## DOCUMENT CHANGE REQUEST

DCR number 271 Changes required for: General

Title: Diodes, Power Rectifier, Schottky Barrier, based on type STPS20100

Number: 5106/016

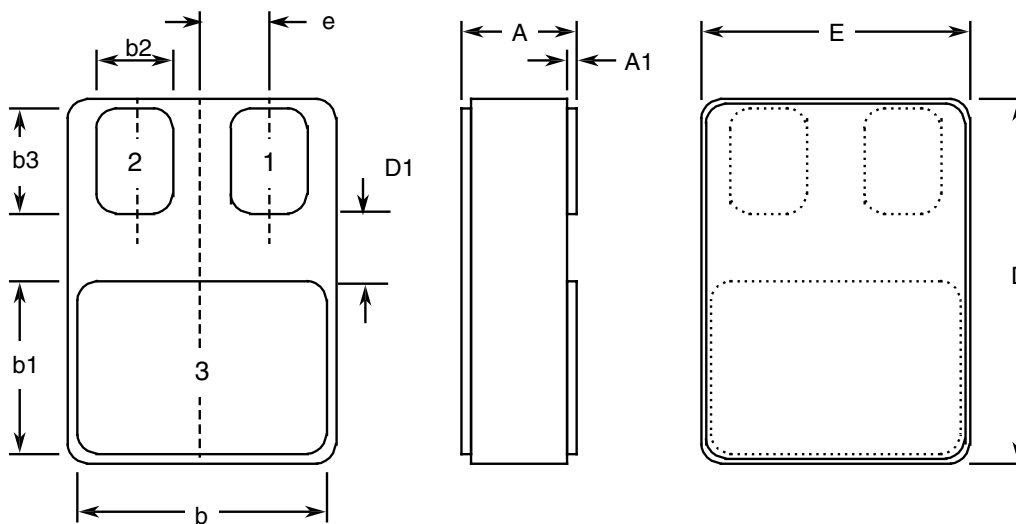
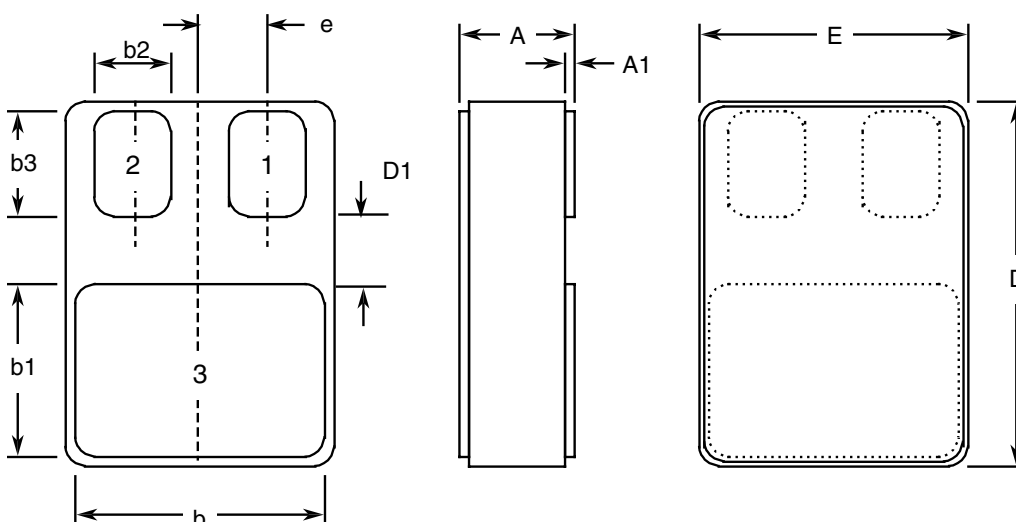
1. Rewording and restructure of various sections and paragraphs of the specification plus other editorial changes based on the layout and editorial content of other Detail Specifications already converted to ESCC format.
2. Deletion of any redundant paragraphs and information, e.g. the mechanical paragraph.
3. Table 1(b) . .Top. rating added and Pulse Condition for .VRRM . rating added.
4. Figure 1 Parameter Derating Requirements - moved to be a note to the Maximum Ratings table.
5. New paragraph for Beryllium Oxide handling precautions added for type variants with the TO-245 package.
6. Figure 2(a) - Dimensions .H., .J. and .K. corrected from "Typical" to "BSC". Dimension .I. corrected to .fl. and .M. to .fM..
7. Figures 2(b) and 2(c) . Dimension .e. corrected from "Typical" to "BSC".

Symbols	Dimensions mm		Notes
	Min	Max	
b3	2.92	3.18	5
D	10.03	10.28	
D1	0.76	-	5
E	7.39	7.64	
e	1.91 BSC		5

Symbols	Dimensions mm		Notes
	Min	Max	
A	3.3	3.61	
A1	0.25	0.51	
b	9.4	9.65	
b1	10.41	10.67	
b2	3.43	3.68	5
b3	3.86	4.11	5
D	15.75	16	
D1	0.76	-	5
E	11.3	11.56	
e	2.67 BSC		5
